WIRELESS STATION A 510

TRANSMITTER AND RECEIVER

REFERENCE:- Aust. Change in W.M. 13061.

1. Since the commencement of manufacture of this equipment several changes in design and construction have occurred, with the result that early sets now require modification. This instruction details all modifications since production commenced and provides a guide list of equipment serial numbers showing their state of modification in manufacture.

FIG. 1

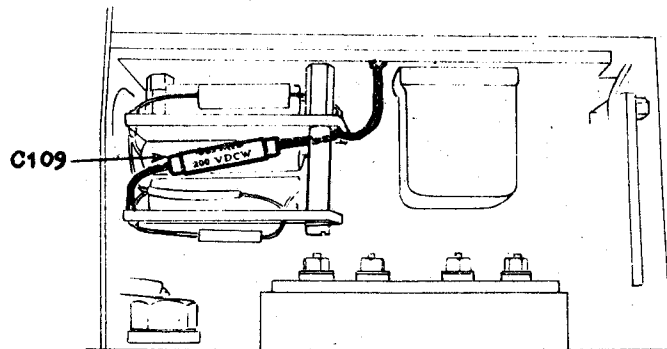
8. Change C 109 in the following manner; (see Fig. 1):-

- (a) Unsolder and remove C 109 (0.01uF).
- (b) Solder new C 109 (0.005uF) into position vacated by the 0.01uF, one end to earth point directly below the spacing pillar, and the other to the top tag diagonally opposite to the earth point.

FIG. 2

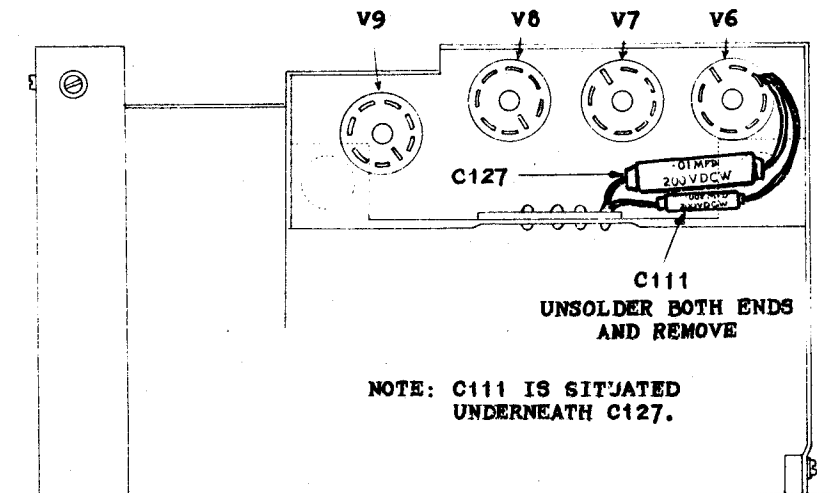
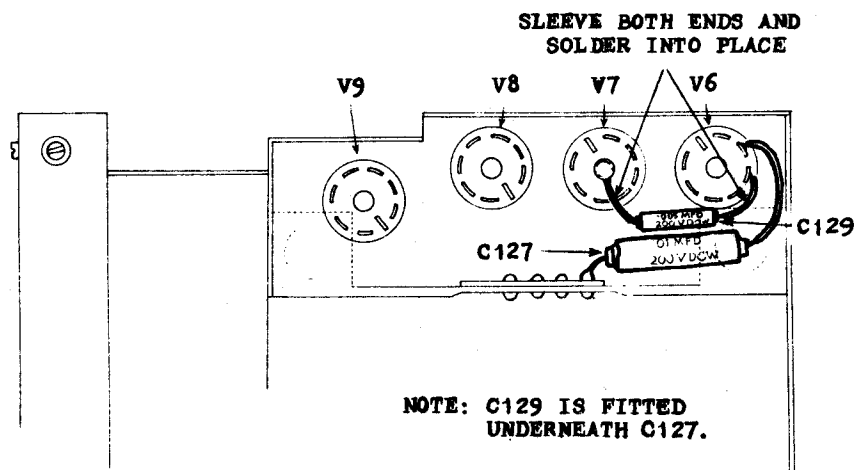
9. Remove C 111 and install C 129 in the following manner (see Fig. 2 and 3):-

- (a) Unsolder and remove C 111 (0.005uF) which is connected from pin 2 of V6 to terminal plate and lies beneath C 127 (0.01uF).
- (b) Place capacitor C 129 in space vacated by C 111 and cut leads to required length.
- (c) Sleeve the pigtails with yellow 1½MM PVC sleeving and solder one lead to pin 3 of V6 and one to the earthed spigot of V7.

FIG. 4

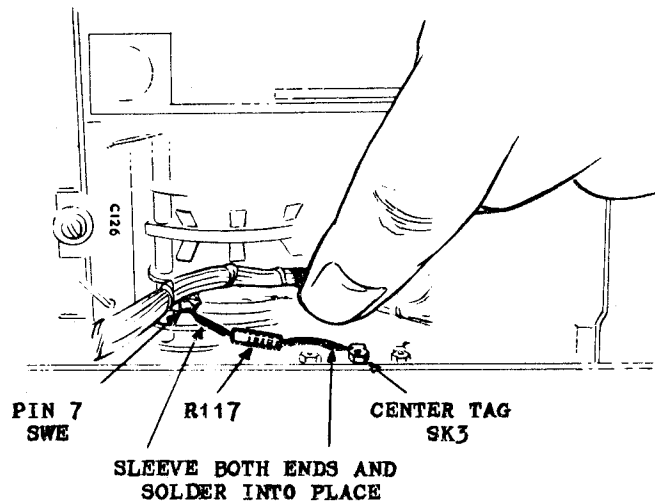
10. Install R 117 in the following manner (see Fig. 4):-
 - (a) Unsolder and remove lead from centre tag of SK3 to pin 7 of switch SWE.
 - (b) Solder R 117 (220,000 ohms $\frac{1}{2}$ W) in position formerly occupied by removed lead.
11. Strike out No "1" on the transmitter and receiver modification plate.
12. Replace transmitter and receiver in cases.
13. Check side tone oscillator keying speed and general function of transmitter.

FIG. 1

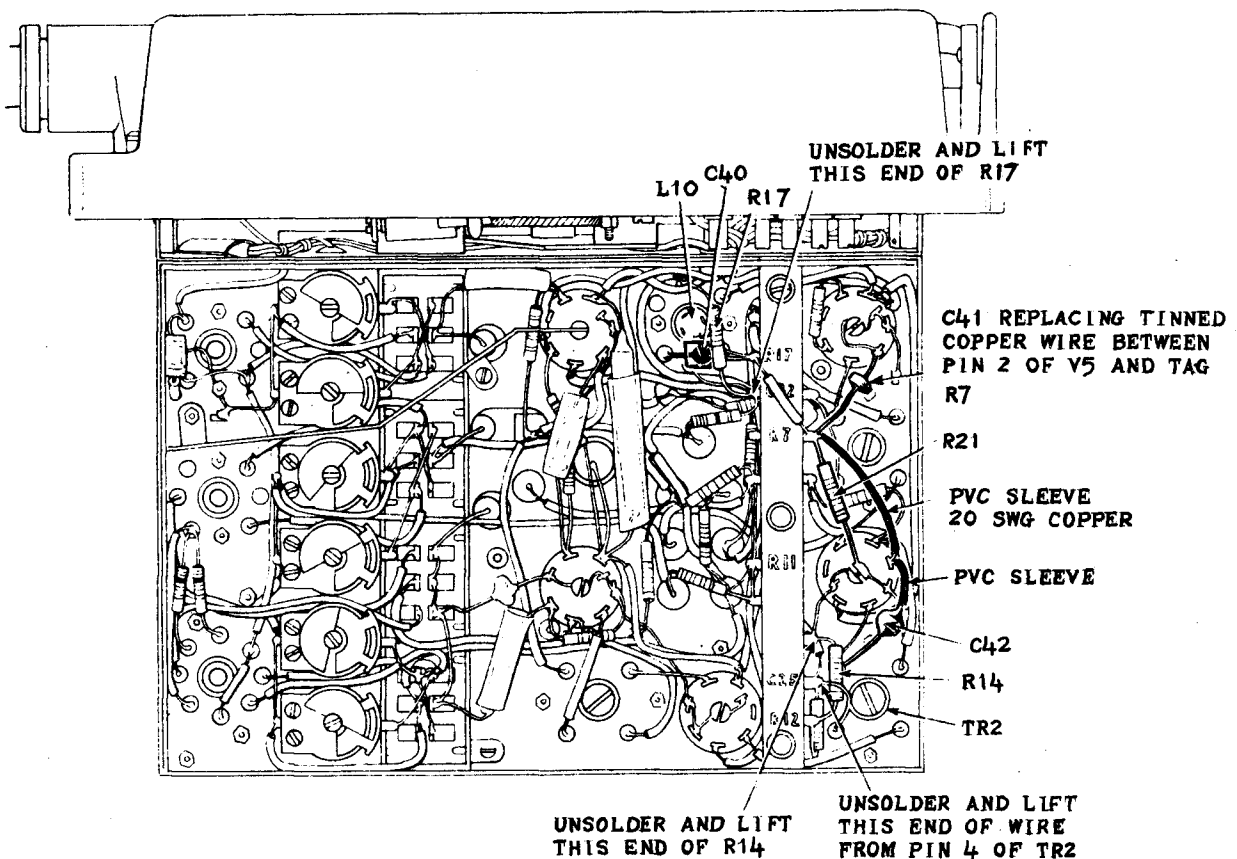
6. Remove receiver chassis from case and install the following as detailed (refer Fig. 1).

- (a) Unsolder and lift end of R17 (47,000 ohms $\frac{1}{2}W$) connected to tag marked C32.
- (b) Cover body of C40 with $\frac{3}{8}$ in. of 10MM. PVC sleeving and solder into place, connecting between pin 1 (green spot) of L10 and the tag marked R17.
- (c) Solder floating end of R17 back to tag marked C32.
